**SUBJECT: OYSTER CREEK GENERATING STATION - NRC LICENSE RENEWAL
FOLLOW-UP INSPECTION REPORT 05000219/2008007**

Report No.: 05000219/2008007

Facility: Oyster Creek Generating Station

Figure A-1, Cross Section of the Oyster Creek Drywell

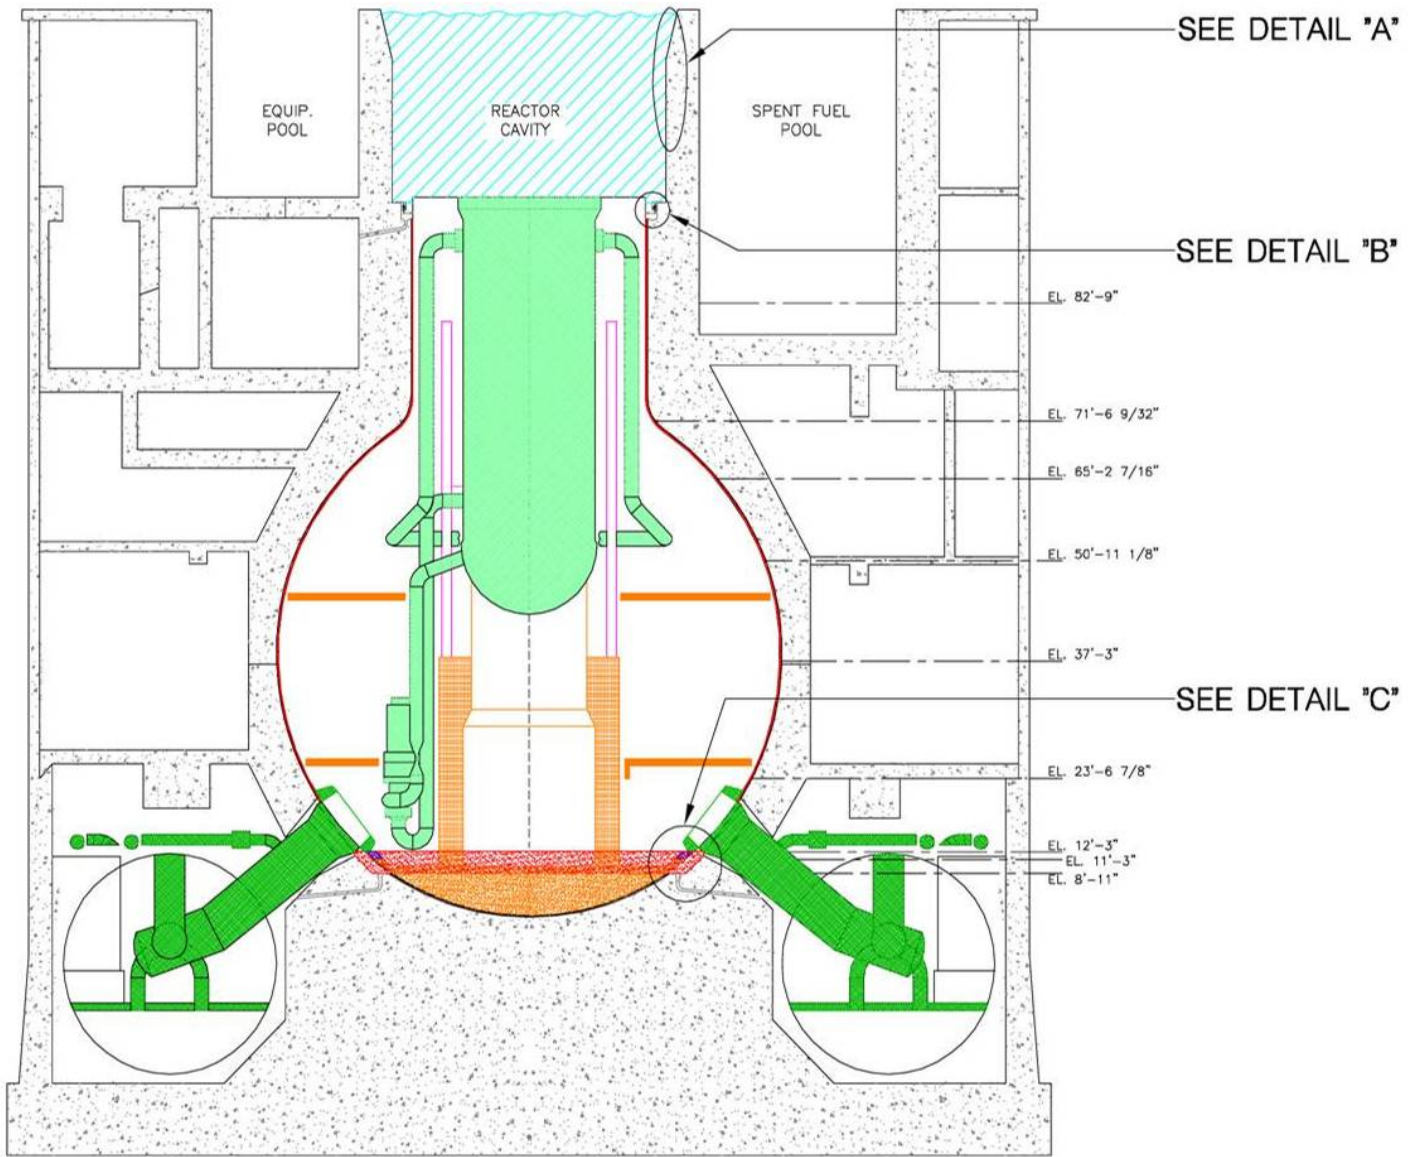
The strippable coating is applied to the reactor cavity liner before the cavity is filled with water to minimize the likelihood of cavity seal leakage into the cavity concrete trough. This action is taken to prevent water intrusion into the gap (Figure A-3) between the drywell steel shell and the concrete shield wall. (see Figure A-1 for general arrangement)

From Oct. 29 to Nov. 6, the cavity liner strippable coating limited cavity seal leakage into the cavity trough drain to less than 1 gallon per minute (gpm). On Nov. 6, in one localized area of the refuel cavity, the liner strippable coating started to de-laminate. Water puddles were subsequently identified in sand bed bays 11, 13, 15, and 17 (see Section 3.5 below for additional details). This issue was entered into the corrective action program as Issue Report (IR) 841543. In addition, this item was included in a common cause evaluation as part of IR 845297. Exelon's initial evaluations identified several likely or contributing causes, including:

Figure A-2, Oyster Creek Reactor Cavity Seal Detail

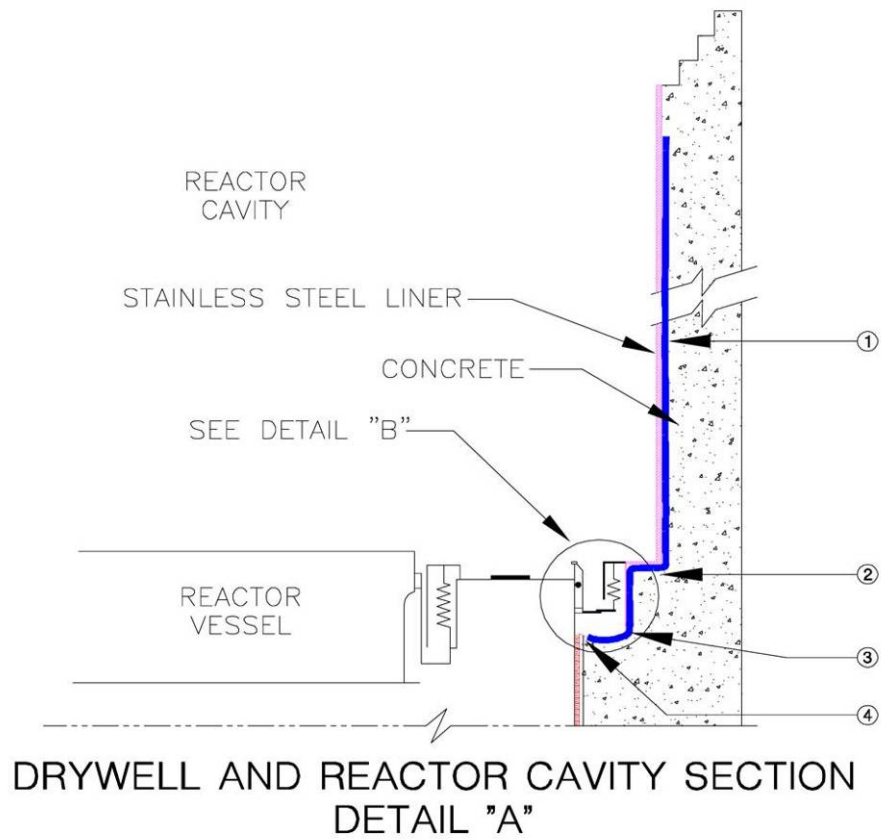
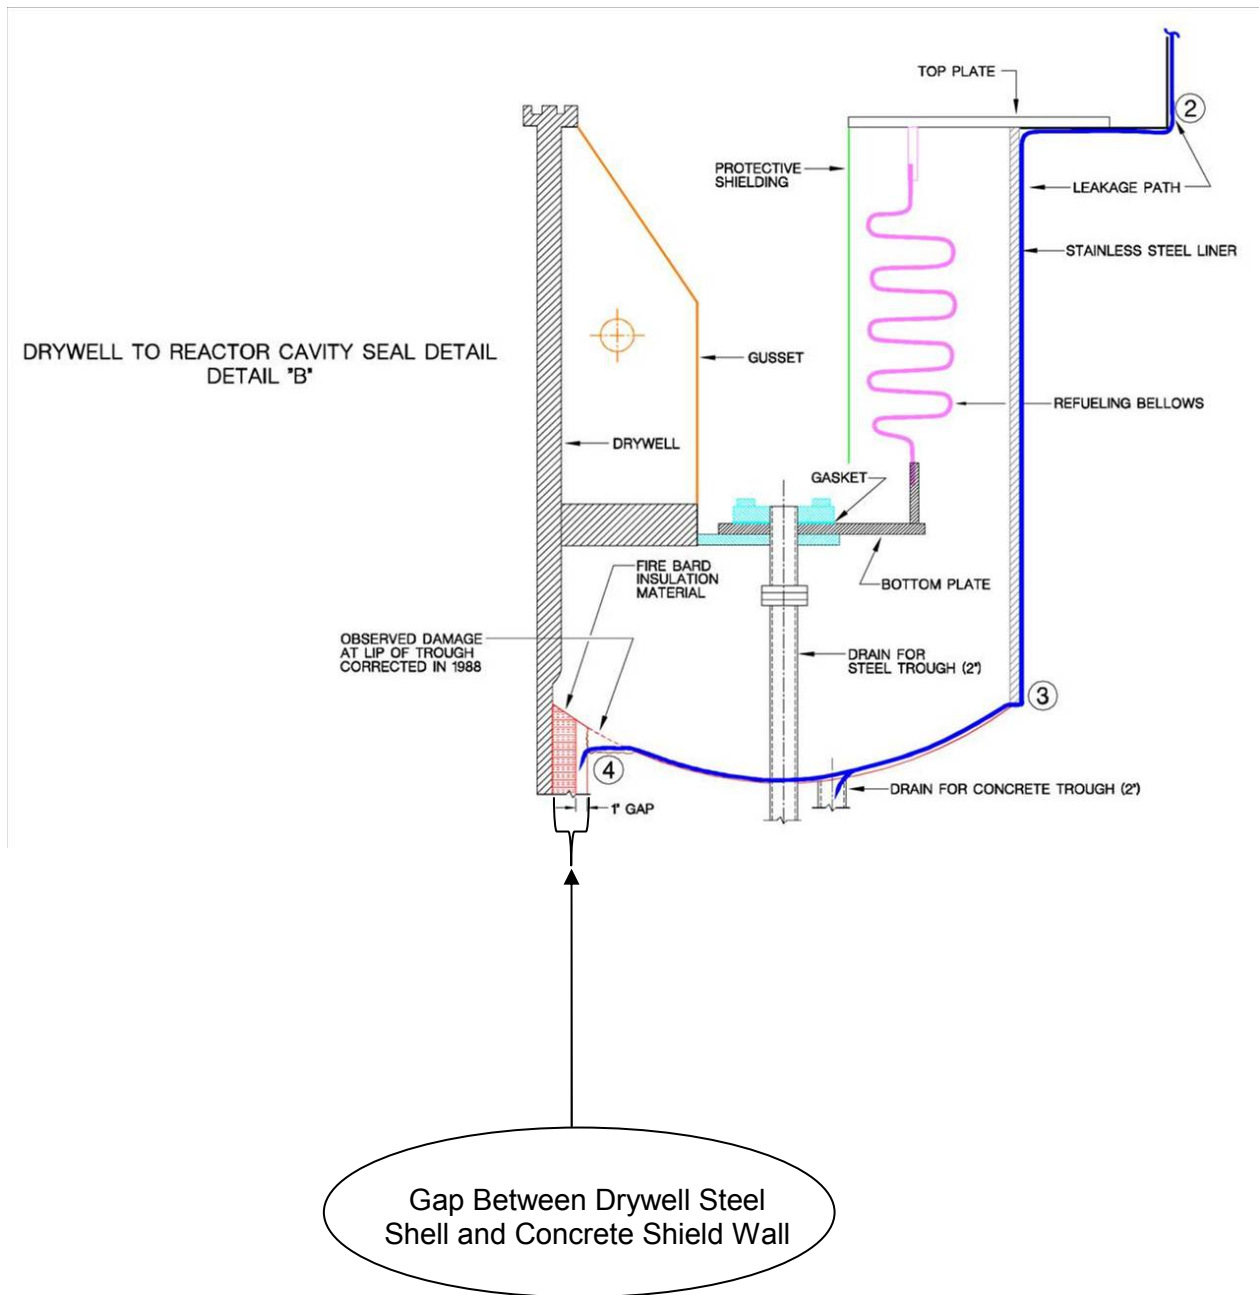
Exelon monitored reactor refuel cavity seal leakage by checking and recording the flow in a two inch drain line from the cavity concrete trough to a plant radwaste system drain funnel which, in turn, drained to the reactor building equipment drain tank. (See Figures A-1 thru A-3)

On Oct. 27, Exelon isolated the cavity trough drain line to install a tygon hose to allow drain flow to be monitored. On Oct. 28, the reactor cavity was filled. Drain line flow was monitored frequently during cavity flood-up, and daily thereafter. On Oct. 29, a boroscope examination of the drain line identified that the isolation valve had been left closed. When the drain line isolation valve was opened, about 3 gallons of water drained out. The drain flow then subsided to about a 1/8-inch stream (less than 1 gpm). This issue was entered into the corrective action program as IR 837647.

For the reactor cavity seal leakage, Exelon established an administrative limit of 12 gpm flow in the cavity trough drain, based on a calculation which indicated that cavity trough drain flow of less than 60 gpm would not result in trough overflow into the gap between the drywell concrete shield wall and the drywell steel shell. (see Figures A-1 thru A-5)

The inspectors also noted that water had entered the gap between the drywell shield wall and the drywell shell at a much lower value of cavity seal leakage than Exelon had calculated and, as a result, water intrusion into the sand bed region occurred at a value below the threshold established in the action plan.

Figure A-4, Oyster Creek Sandbed Region Detail Showing the Sandbed Drain Line

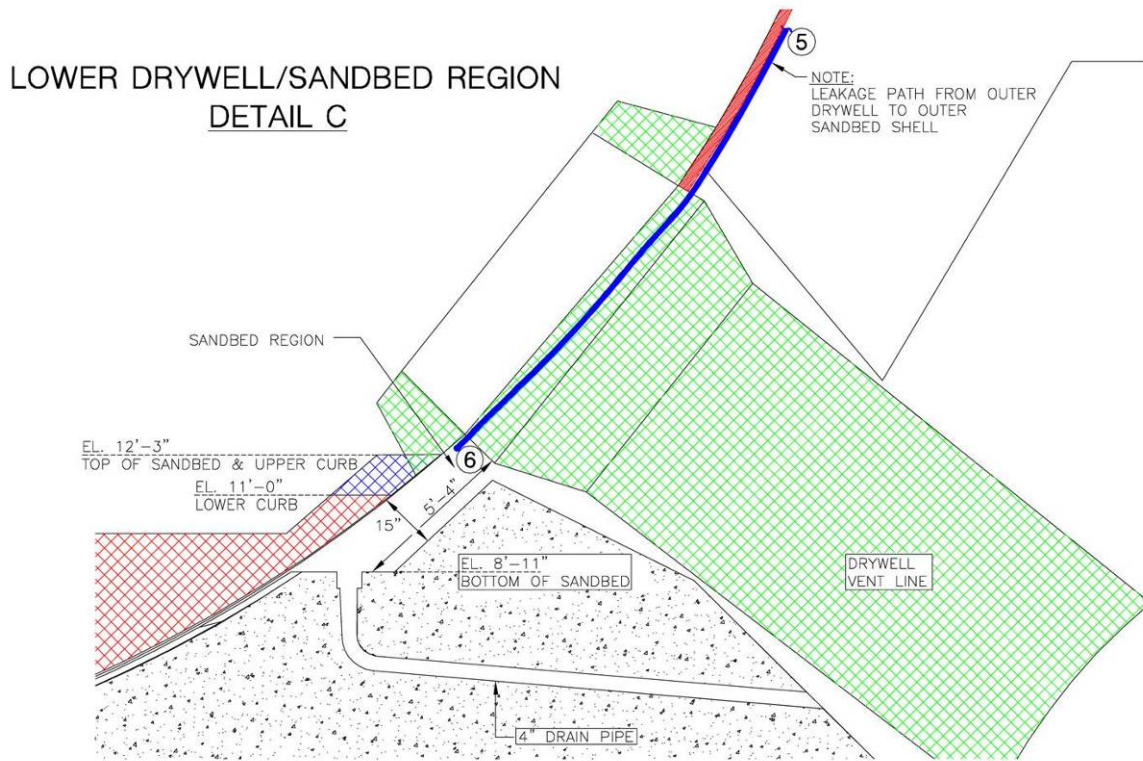
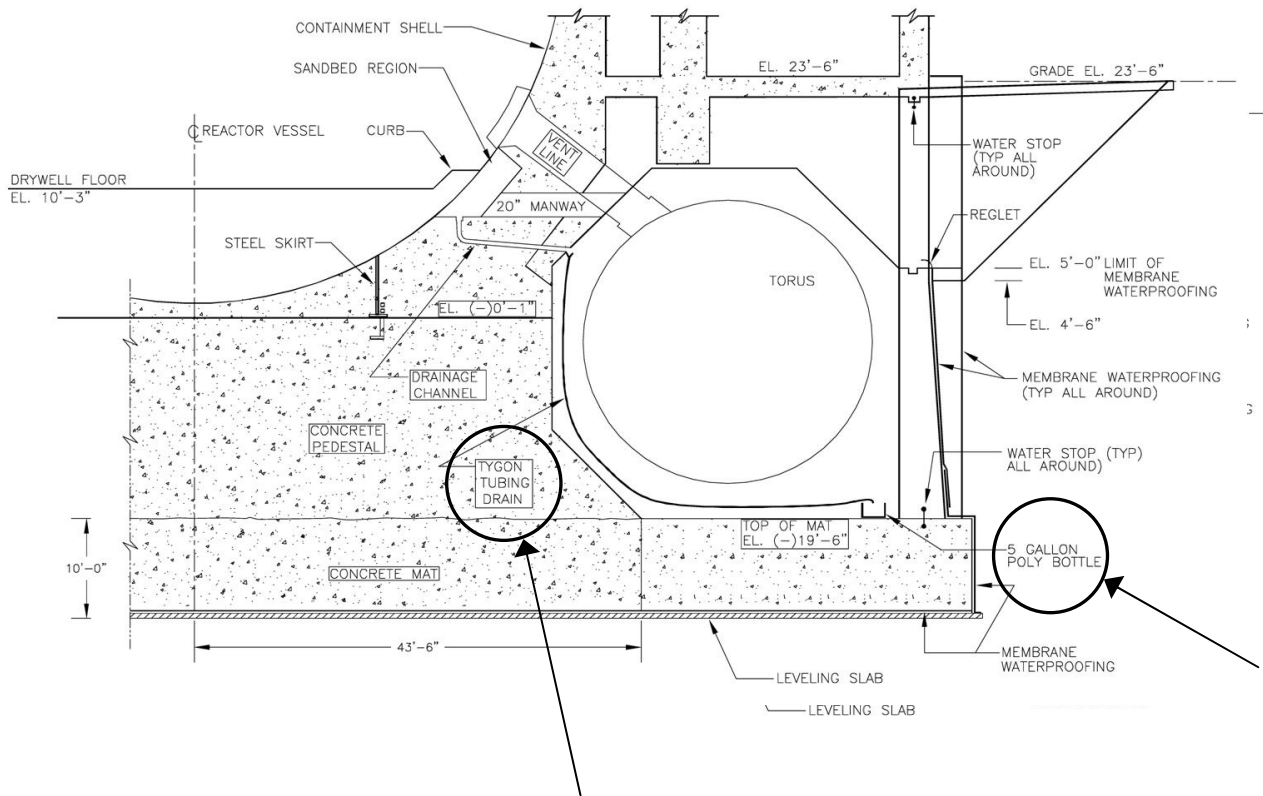
There is one sand bed drain line for every two sand bed bays (i.e., total of five drains for 10 bays). Exelon remotely monitored the sand bed drains by checking for the existence of water in poly bottles attached via tygon tubing (approximately 50 foot long) to a funnel hung below each drain line. The sand bed drains, funnels, and a majority of the tygon tubing were not directly observable from the outer area of the torus room, where the poly bottles were located. (see Figures A-1, A-4, & A-5)

On Nov. 10, Exelon found two of the five tygon tubes disconnected from their funnels and laying on the floor (bays 3 and 7). Exelon personnel could not determine when the tubing was last verified to be connected to the funnel. The inspectors directly observed that the torus room floor had standing water for most of the outage, due to other identified system leaks. The inspectors noted that the standing water would have prevented Exelon personnel from determining whether any water had drained directly onto the floor from a sand bed drain during the time period that the tygon tubing was disconnected. The inspectors also noted that bays 3 and 7 remained dry throughout the outage, with no identified water intrusion (see observations in Section 3.5). Both tubes were subsequently reconnected. This issue was entered into the corrective action program as IR 843209.

On Nov. 15, during a daily check of the sand bed bay 11 drain poly bottle, Exelon found the poly bottle nearly full. Chemistry collected about 4.3 gallons out of the poly bottle and tubing. The inspectors noted that Exelon had found the poly bottle empty during each check throughout the outage until Nov. 15, and had only noted water in the poly bottle three days after the reactor refuel cavity had been drained. In addition, the inspectors noted that the poly bottle had a capacity of about 5 gallons and the funnel had a capacity of about 6 gallons, which suggested that the funnel had not overflowed. Finally, the inspectors noted that Exelon entered bay 11 within a few hours of identifying the water, visually inspected the bay, and found it dry. Exelon sampled the water, but could not positively determine the source based on radiolytic or chemical analysis. This issue was entered into the corrective action program as part of the common cause evaluation IR 845297.
